# Certificate of Appropriateness Amended

<b>Property</b>	832 N. 29TH ST.	Concordia Historic District
<b>Description of work</b>		
<b>Date issued</b>	11-21-2017	PTS ID 111144 COA Amends COA of 05-27-2016 and 08-18-2016

This certificate amends COAs previously issued on May 27, 2016 and August 18, 2016 and supersedes those prior documents. The current COA is the result of meetings between city staff, the city attorney’s office, the property owners, the owners’ contractors and the owners’ attorney. It outlines all of the work required to meet Historic Preservation requirements.

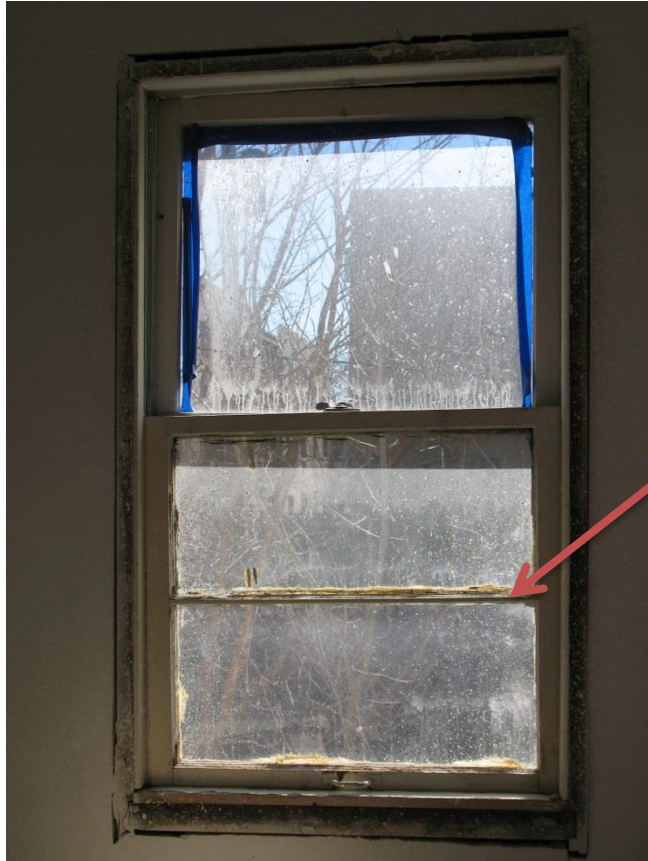
The large landscape sash at the front of the house (west elevation) will be returned to its original condition with one large pane of glass below the fixed transom window. The bottom storm window on the exterior can remain with two panes of glass.
